CONWAY
HISTORIC DISTRICT COMMISSION
STAFF REPORT

5:30 pm • October 28, 2019 • City Hall

I.A MOFFETT HOUSE EXTERIOR MODIFICATIONS - 1616 ROBINSON AVENUE

II.A NEW SINGLE-FAMILY RESIDENCE - 2030 DUNCAN STREET

AFTER view of subject property from Robinson Ave looking northeast

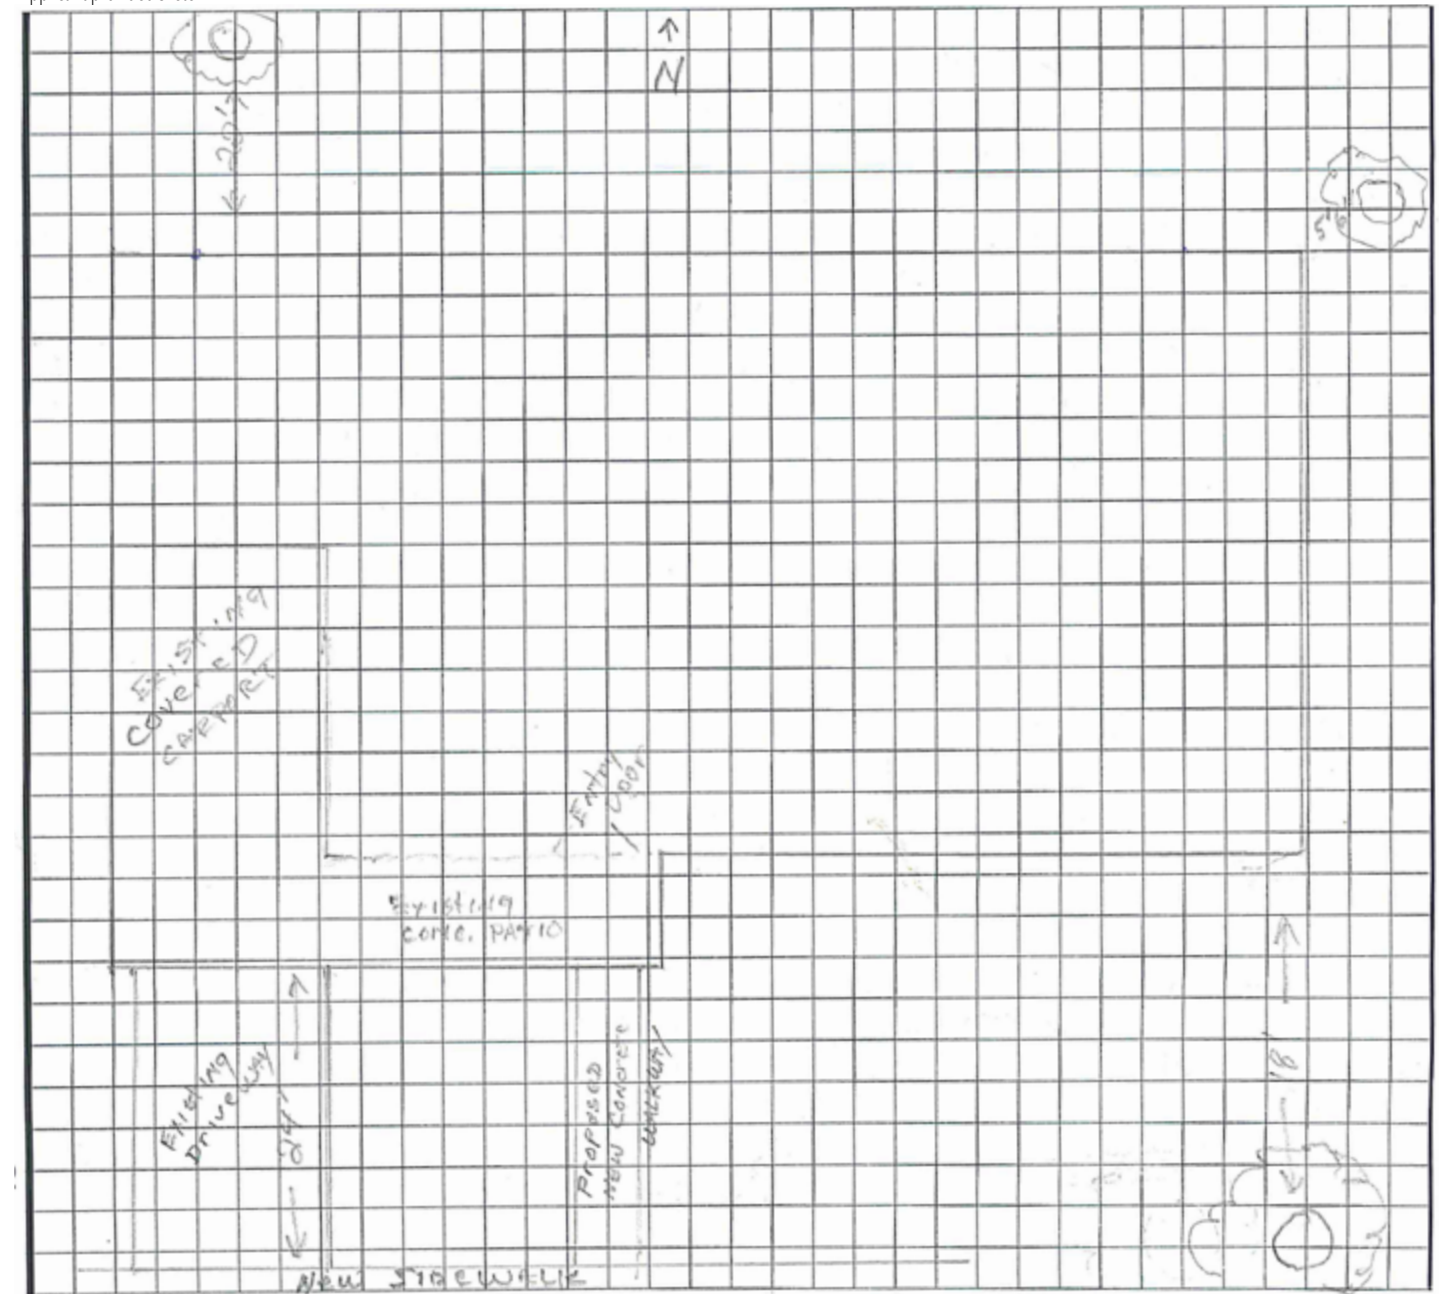
The applicant has proposed to remove and replace the existing damaged/rusting metal support columns with wood columns, add a privacy trellis to the front of the structure and along the carport, paint the masonry exterior of the house, and replace the existing damaged sidewalk. All improvements excluding painting the brick are reversible and impact elements that needed replacement rather than repair.

The applicant's proposal to paint the existing brick is not appropriate.

The structure in question is non-contributing and does not fall within the period of significance for the district. Additionally, replacement of the existing columns was necessary due to excessive rusting. As such, while the improvements that have been made to the structure are not ideal, they are reversible and made to a structure that is already non-contributing.

1. The painting of the masonry on the structure is not approved. However, it is recognized that removal of the paint would likely cause damage to the masonry. As such, removal of the paint is not recommended at this time. Staff has determined that painting of the brick was not done in a manner that was directly intended to subvert the district's design guidelines.
2. HVAC and utility equipment shall be appropriately located at the rear or side of the structure and/or appropriately screened.

Site plan

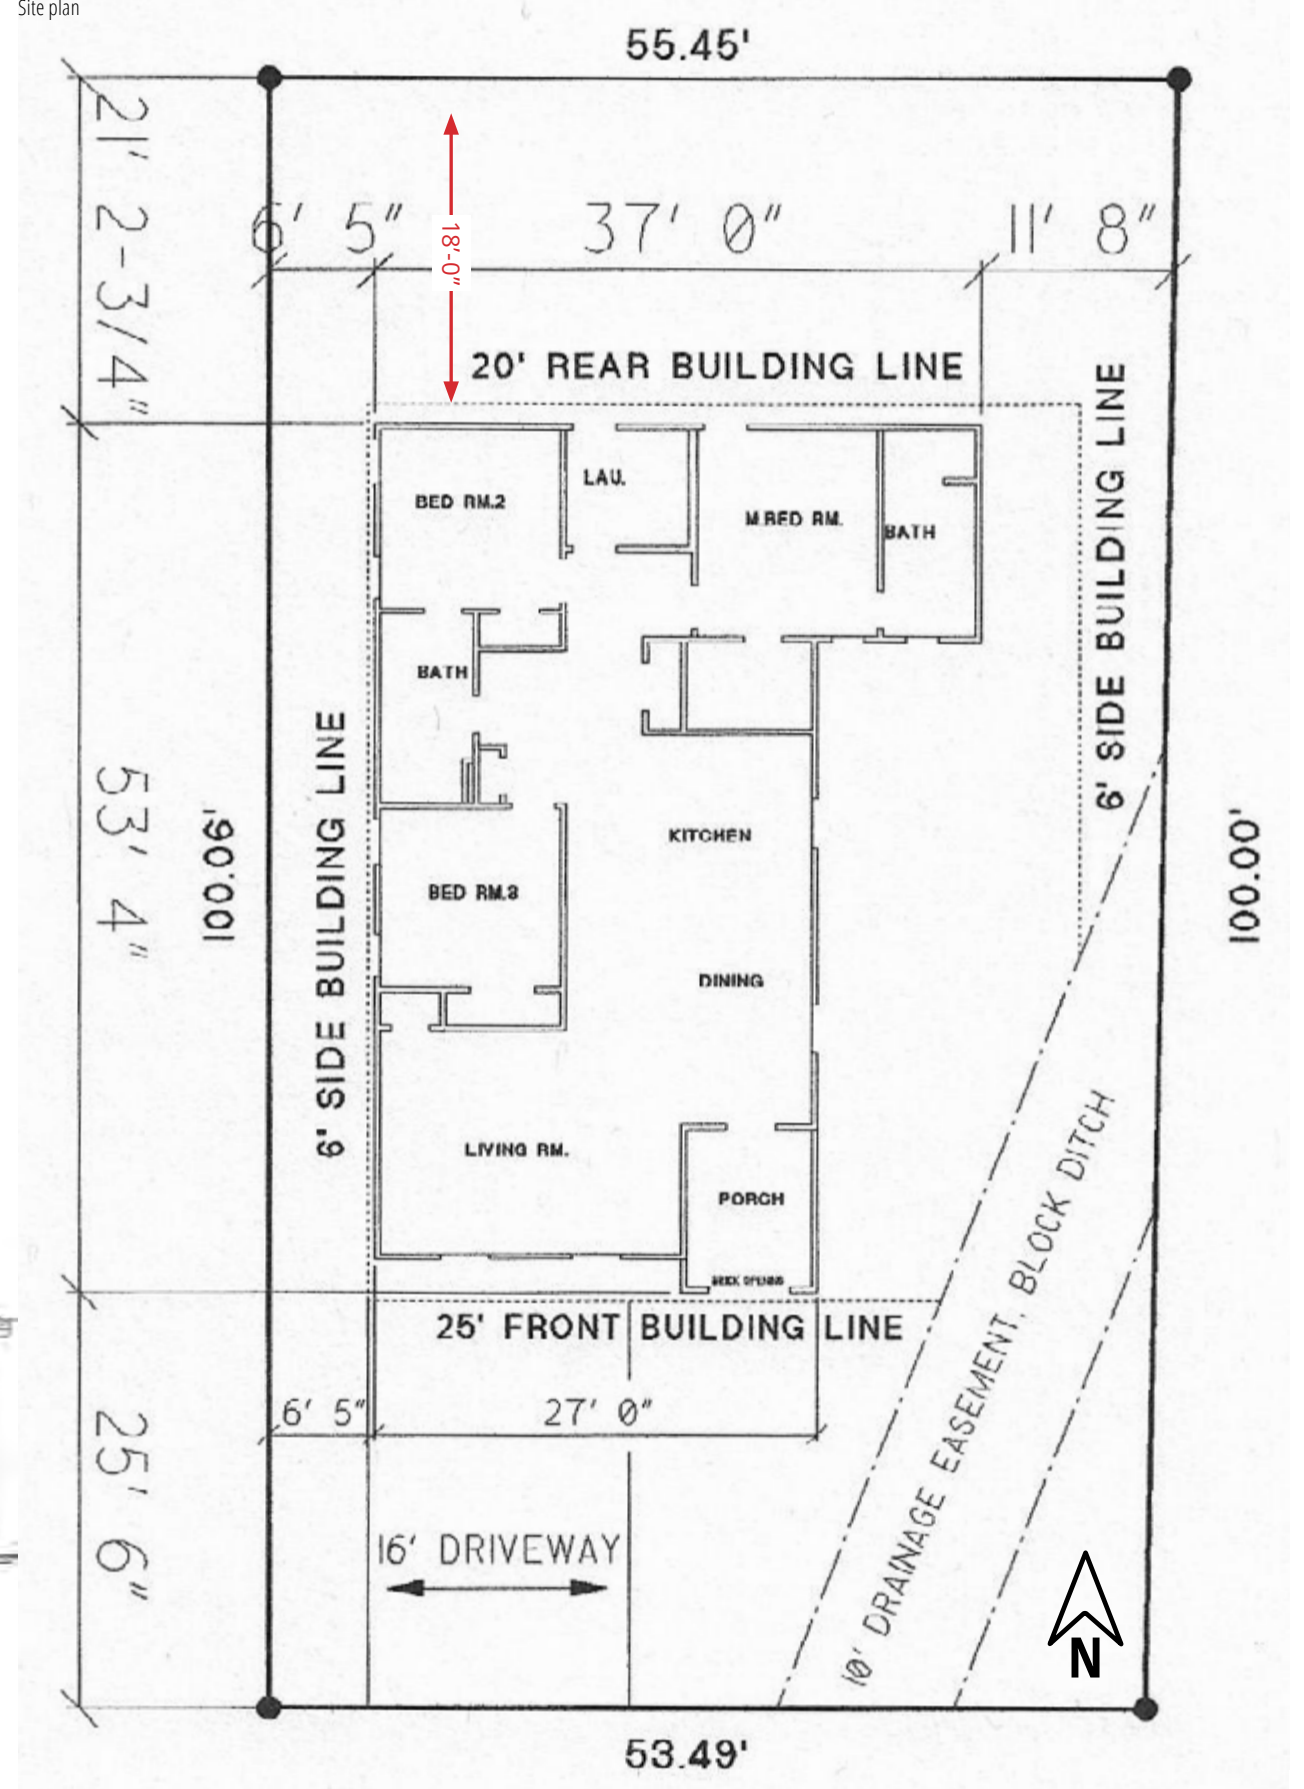
Setbacks and Spacing. Front setbacks are allowed within a range of 85% to 115% of the average front setback of the area. The average setback from the property line for the area is 24.5', based on the properties to the east and west. The included drawings indicate a setback of 25'. The other proposed setbacks conform to the zoning requirements, but the rear setback may be reduced to meet the minimum requirements of the fire code.

The proposed setbacks and spacing are appropriate. However, the front setback could be reduced to 21' to accommodate parking in the back and meet the intent of other regulations of the district. Spacing of the structure appears to conform to the requirements.

The applicant is proposing parking in the front yard. The applicant currently owns the adjacent lot. Recommend requiring a 5' access easement be placed along the east property line of the adjacent property to allow a 10' driveway along the west side of the proposed home. This would allow an 18' X 20' carport on the back side of the house, if the house is setback at 21'.

A semi-enclosed front porch with an 8' depth is proposed. Recommend requiring a small arched window, as indicated in the included graphic, be added to enhance entry detailing. The stucco and wood detailing on the upper façade is appropriate. Windows will require true divided lights.

1. Applicant reduce the front setback to 21' to accommodate a rear carport/garage. This would include requiring a 5' access easement to be provided on the adjacent lot (owned by the applicant) with a 10' driveway to the rear of the subject property.

4. The gabled front entry area include an all brick façade surface.
5. Require a small arched window or similar window appropriate to the style above the front entry.

East elevation

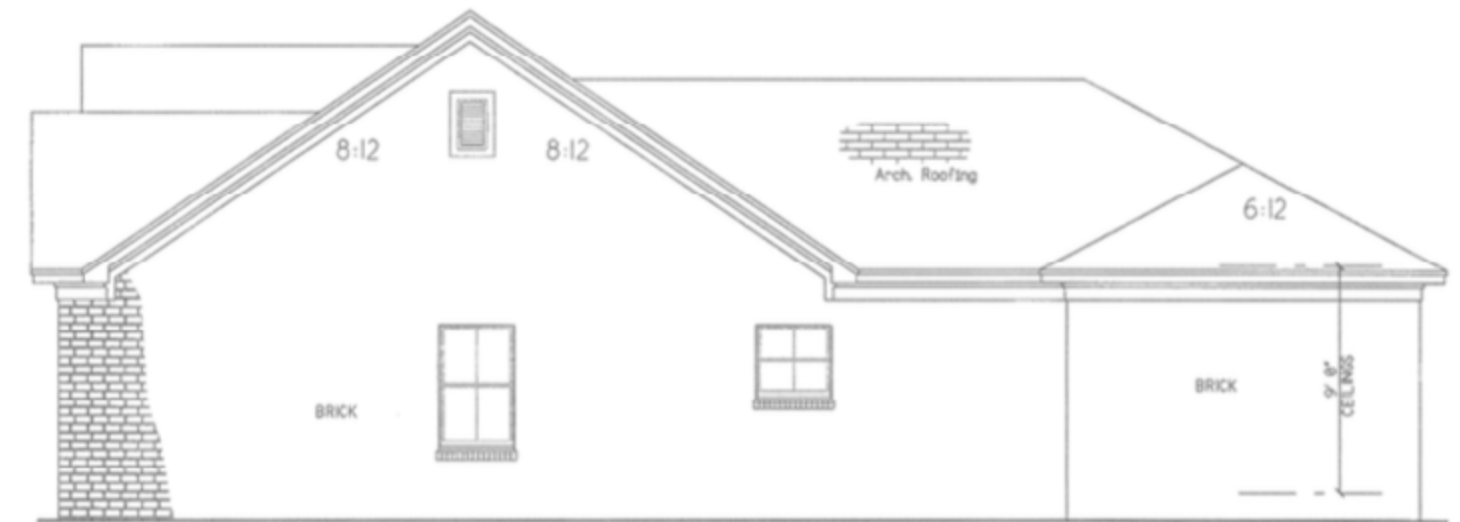
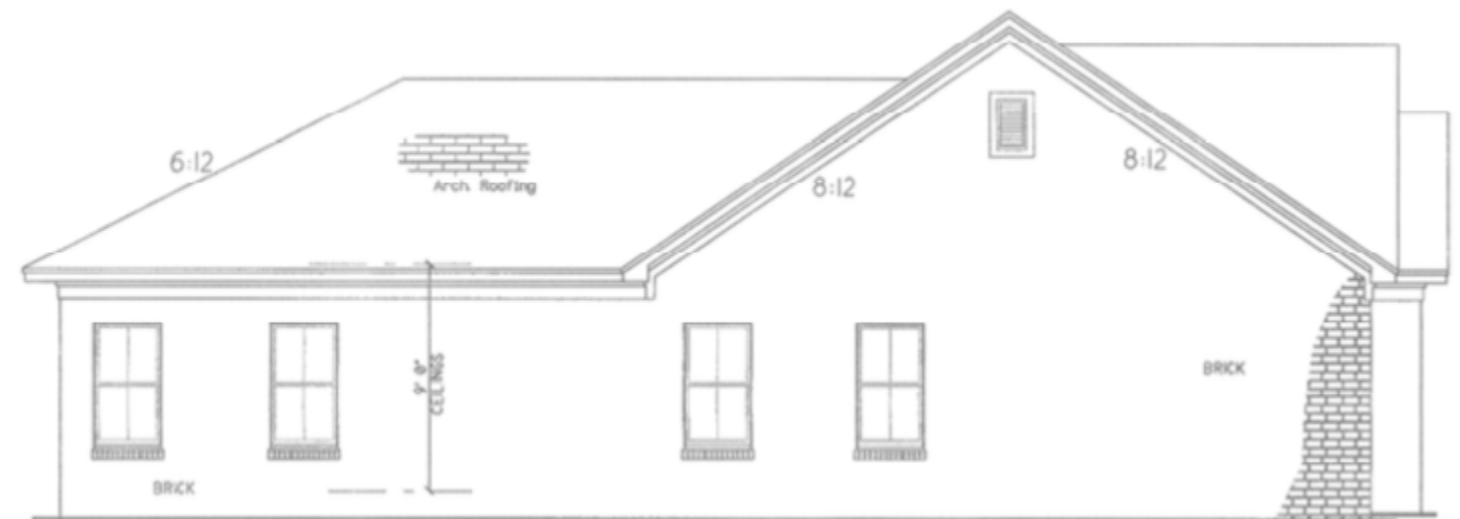
The proposed facades are compatible with the surrounding area. 21% of the front façade's area is devoted to windows and openings. The style and detailing of the home make conformance to this requirement difficult. As such the submitted design is appropriate with some minor window detailing added.

Siding is proposed as brick and stucco with wood detailing. Fascias and soffits should be required to be of wood construction.

6. Require true divided light windows if 4 over 4 windows are included as proposed. 1 over 1 windows may also be allowed.
7. Require fascia and soffits to be finished with wood construction.

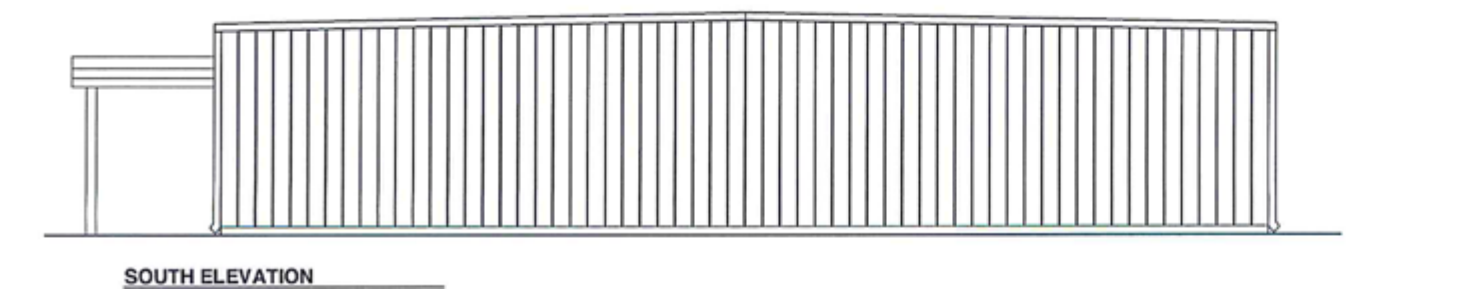
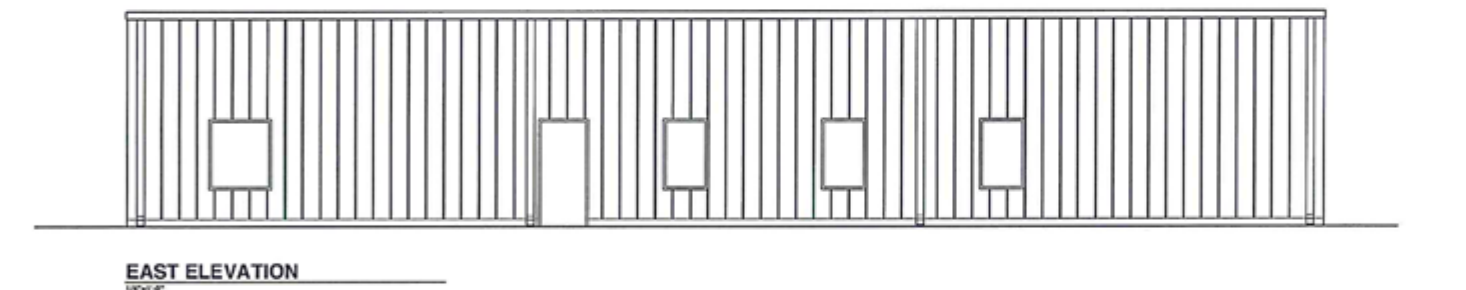
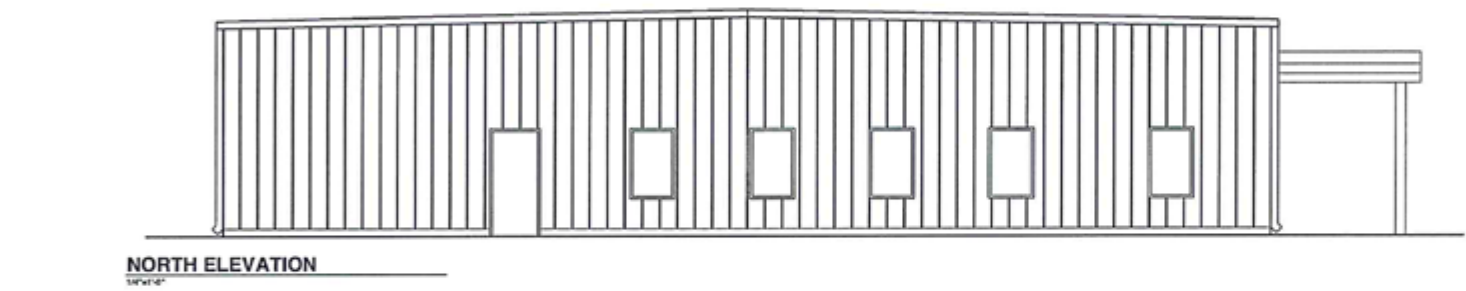
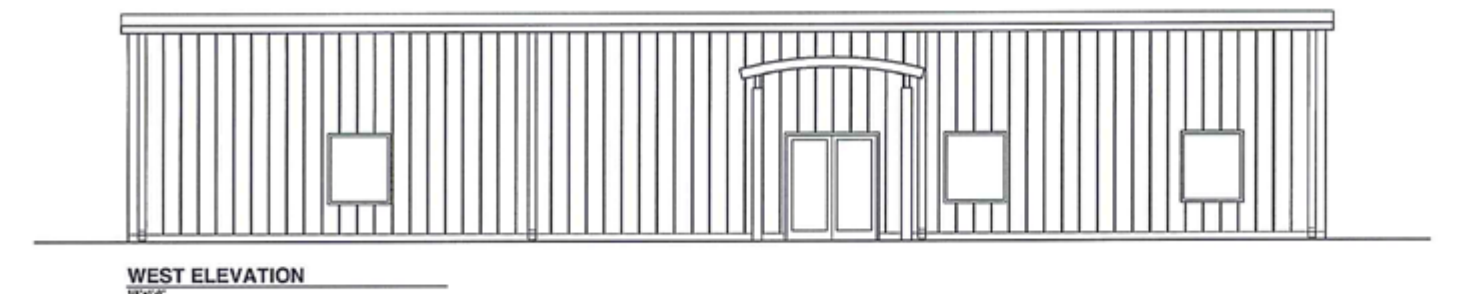
Façade, wall area, rhythm. As proposed, the front façade of the structure will not meet the standards of the Overlay District, however the proposed building is temporary and will be removed after a specified period of time.

Architectural Details, Siding, and Bricks. Detailing is uncertain from the application. The building will be clad in metal.

Shutters, Roof, Decks/Plaza Space, Skylights, Mechanical Screening. The applicant is proposing a minimally sloped metal roof.

Recommend requiring that HVAC not be placed at the front of the building.

1. The building shall be removed prior to October 28, 2022. In the event that the applicant wishes to make the building permanent, an application for a Certificate of Appropriateness shall be approved by the Historic District Commission prior to October 28, 2022.
2. HVAC equipment be placed in a manner to minimize its visibility from the street. Landscape screening may be required.
3. No trees shall be removed as part of the development.

2 NORTH ELEVATION
1/4" = 1'-0"

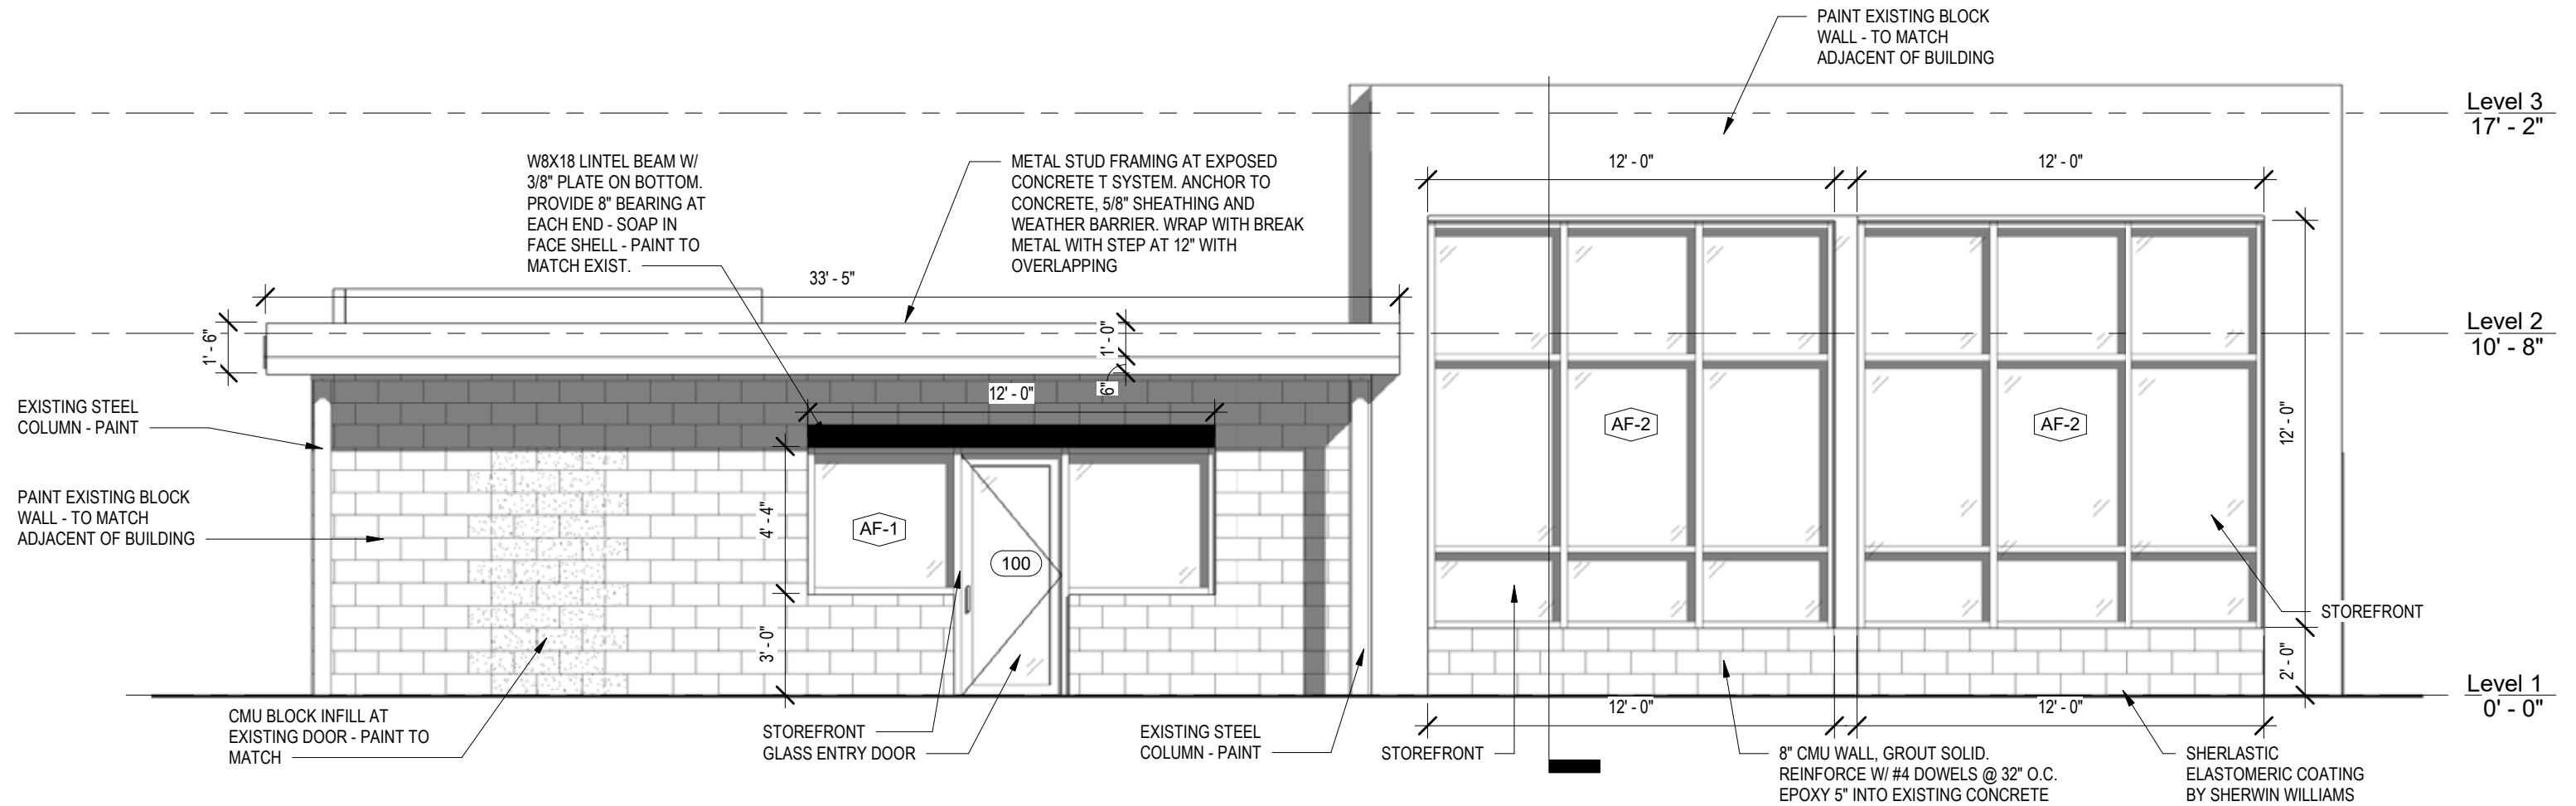
General Description of Property and Proposed Development. The applicant is proposing to replace existing overhead doors with glass storefront and a new entryway on the north side of the building. The building is currently used for storage but is being remodeled to accommodate additional office space. The proposed change to the building will not be visible from any public right of way.

The application meets this requirement. The entire area of the existing storefront openings will be replaced by windows and entries.

The applicant is not proposing frosted or tinted glass on any windows.

Staff recommends approval of the application.
